CITY OF TULSA
PUBLIC WORKS
Engineering

ADDENDUM NO. 4

ADDENDUM NO. 4
TO
PROJECT NO. 2036W0001Z, 2036A0024Z & TMUA-W 22-37
ARTERIAL STREET RECONSTRUCTION GILCREASE MUSEUM RD. (N. 25th W. AVE.) W. ADMIRAL BLVD. TO W. PINE ST.

ADDENDUM NO. 4
TO
GILCREASE MUSEUM RD.
(N. 25TH W. AVE.)
W. ADMIRAL BLVD TO W. PINE ST.
PROJECT NOS. 2036W001Z, 2036 A0024Z & TMUA-W 22-37

I:\21-1009 25th Widening\Plan Sheets\RoadwayShts\21-1009-Signing and Striping Plan.dgn

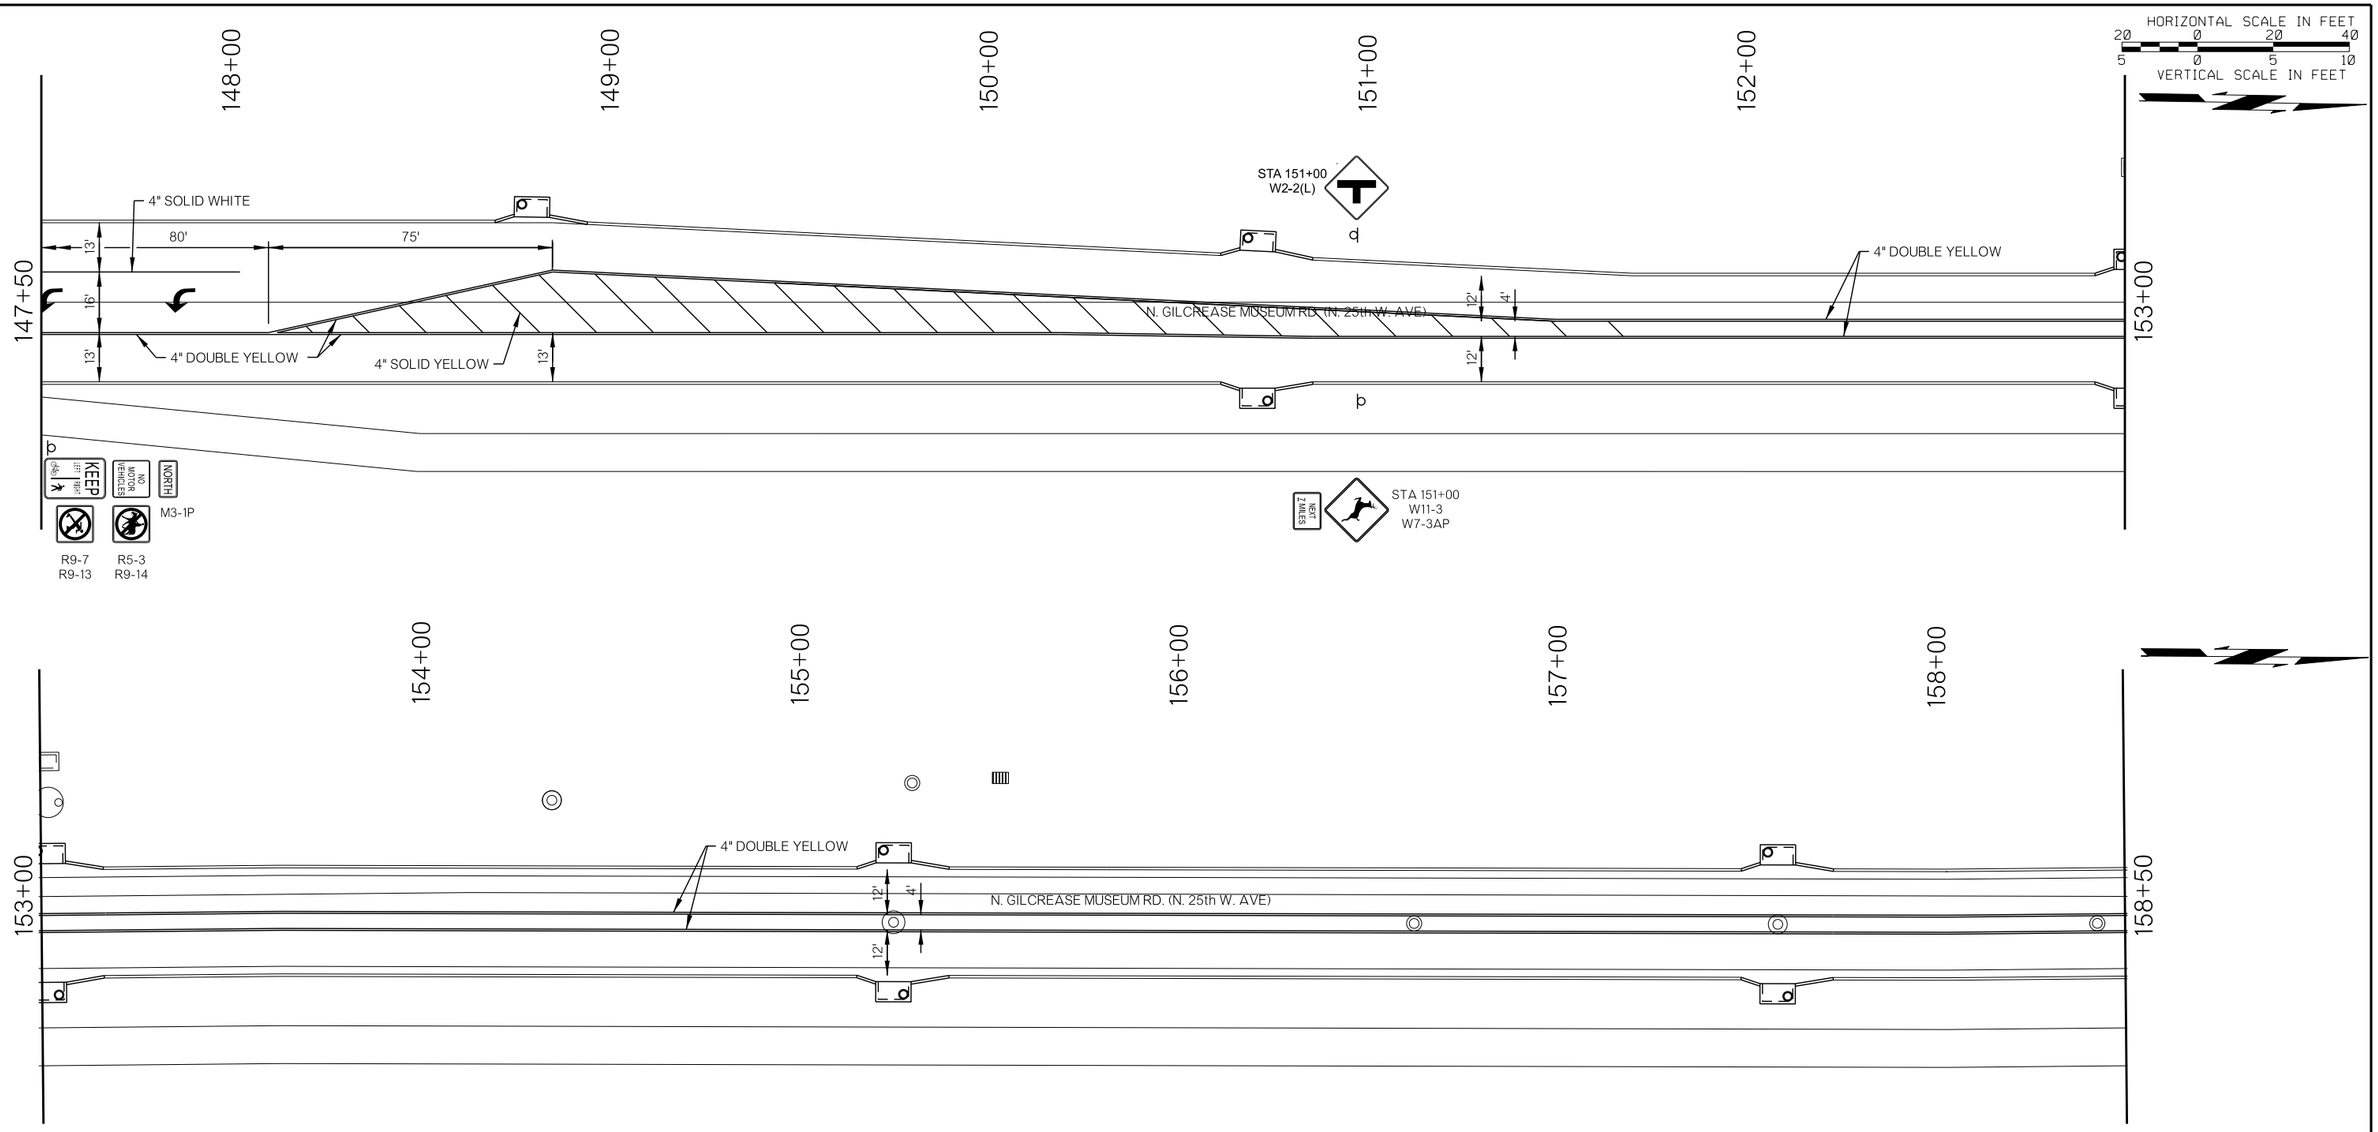
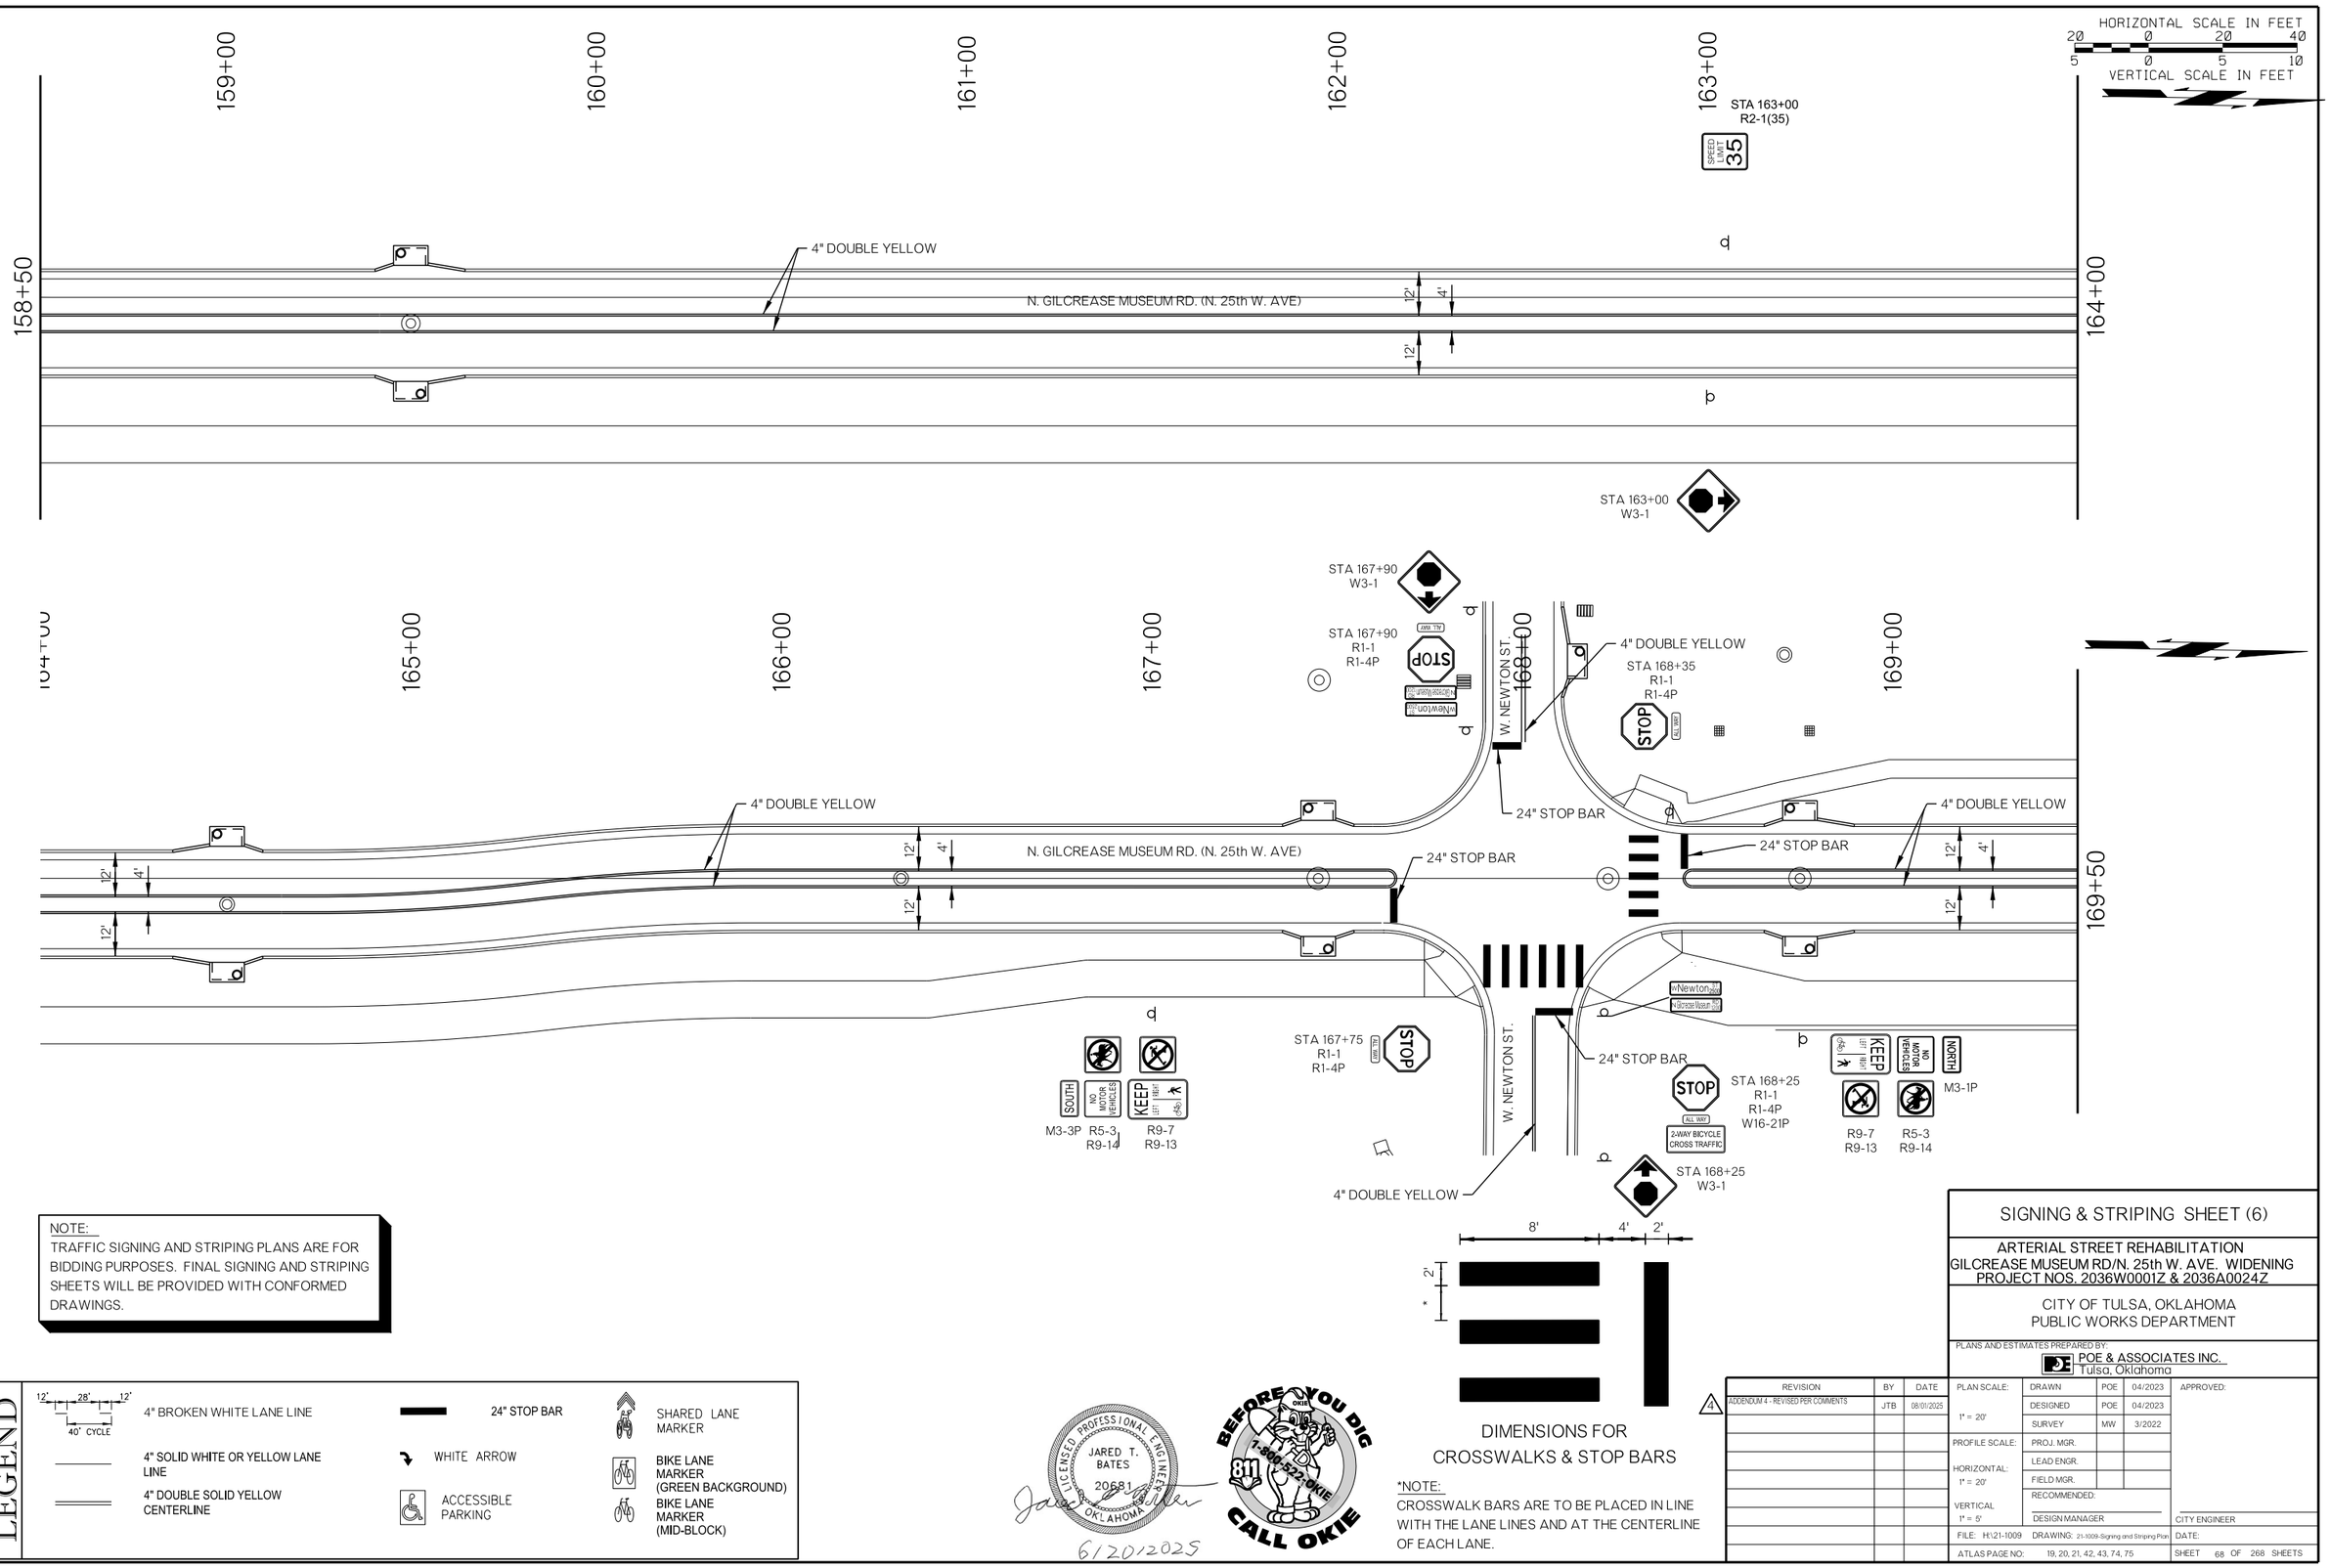
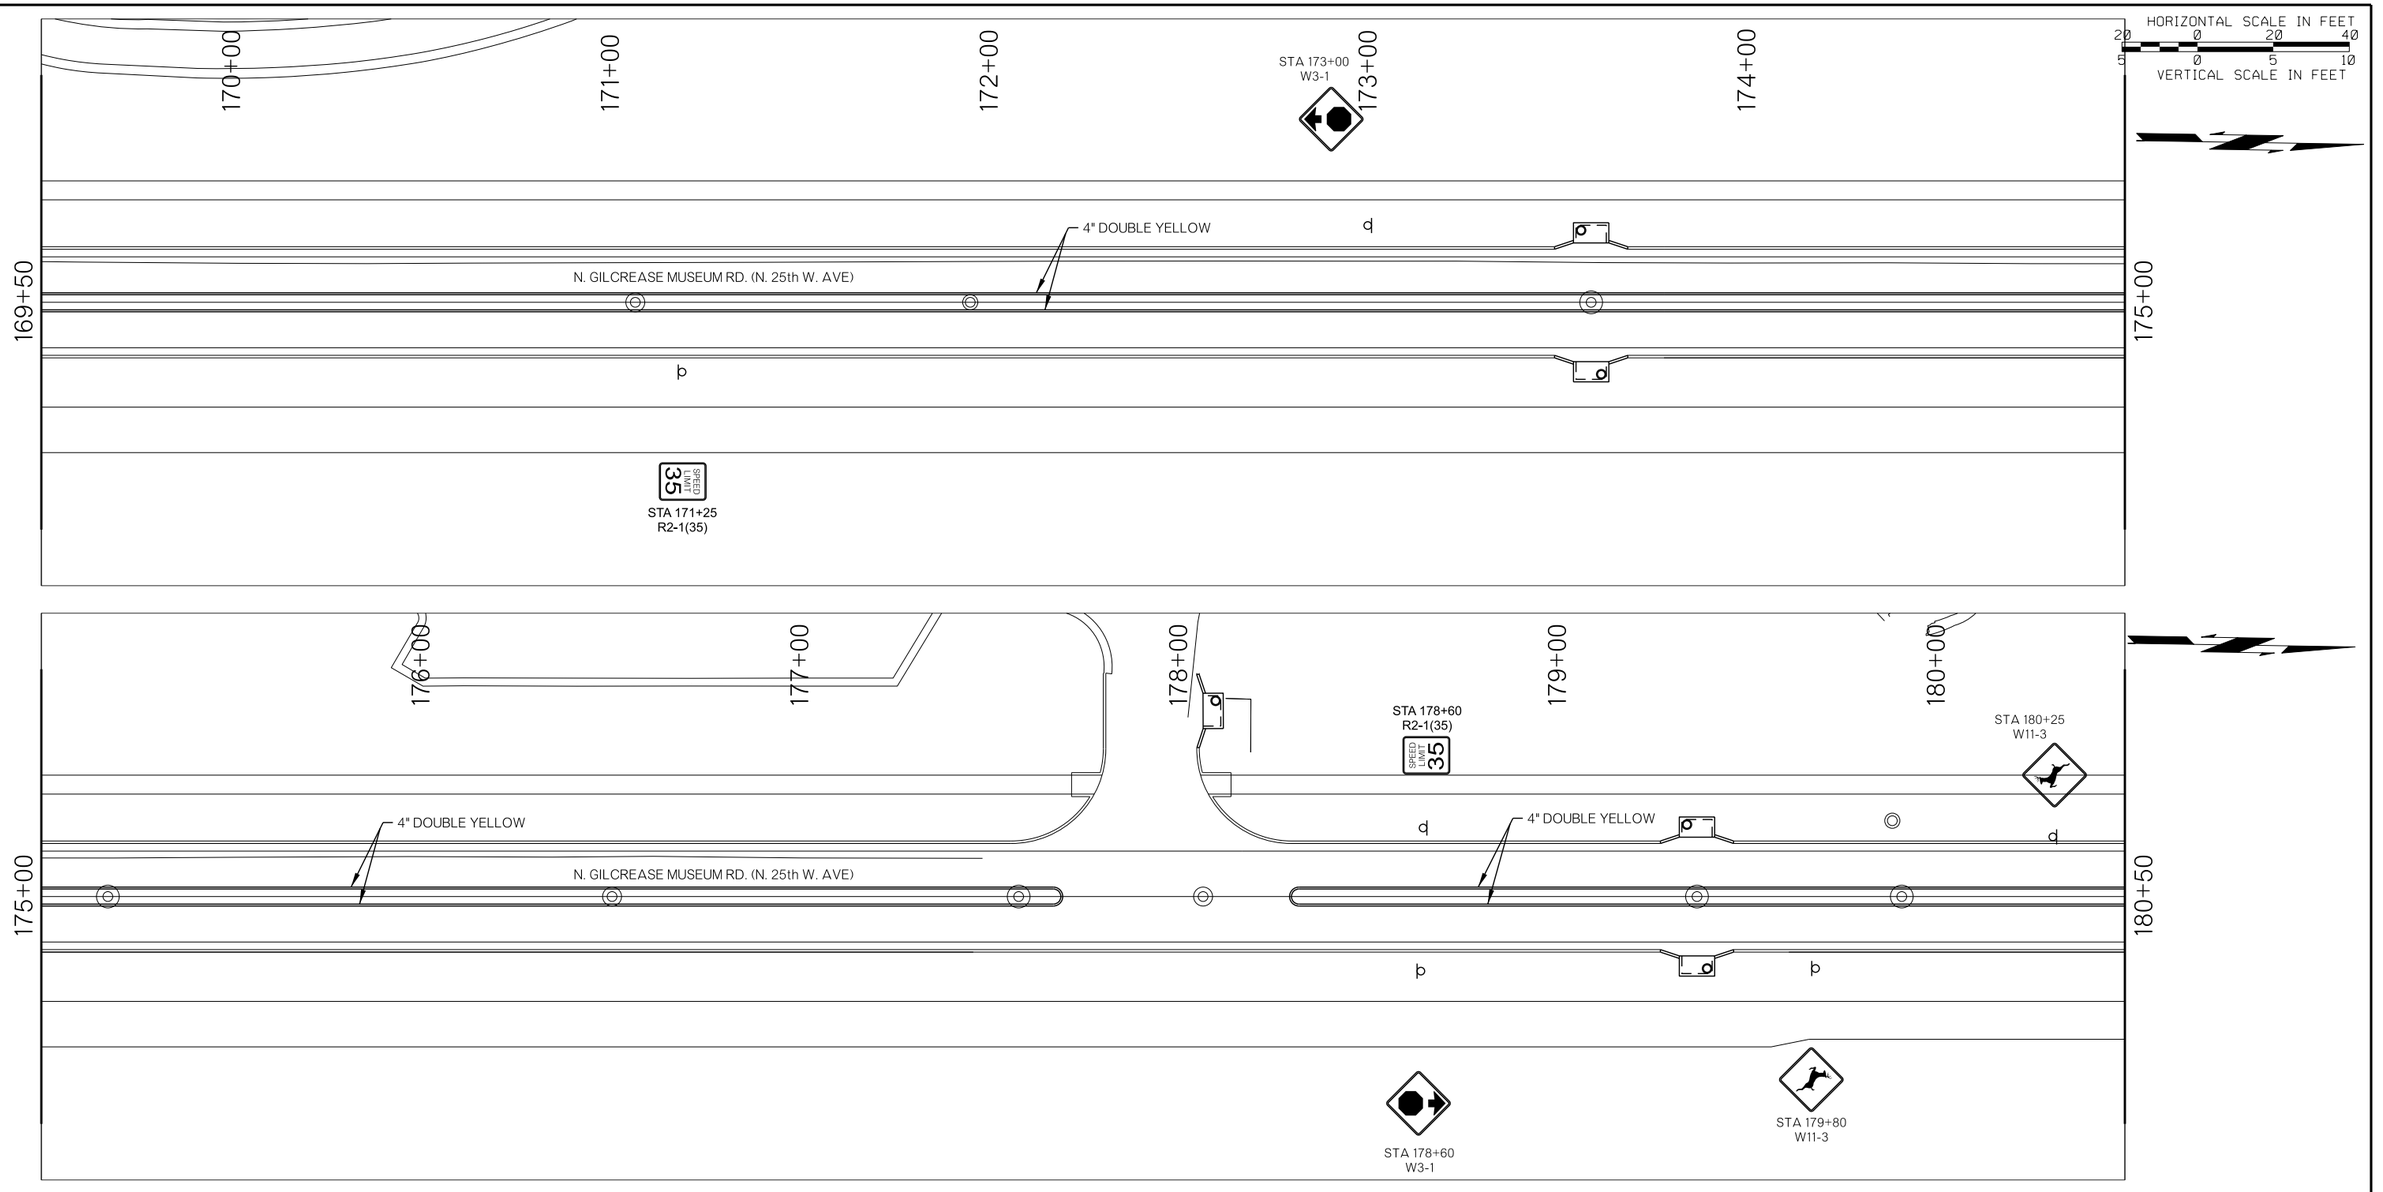
- Nos. 63 to 70 with revised Signing and Striping. Some Trail Signage removed.
- Nos. 71 to 73 with revised Joint Layouts to match striping.
- No. S1 with revised Quantities and Notes.
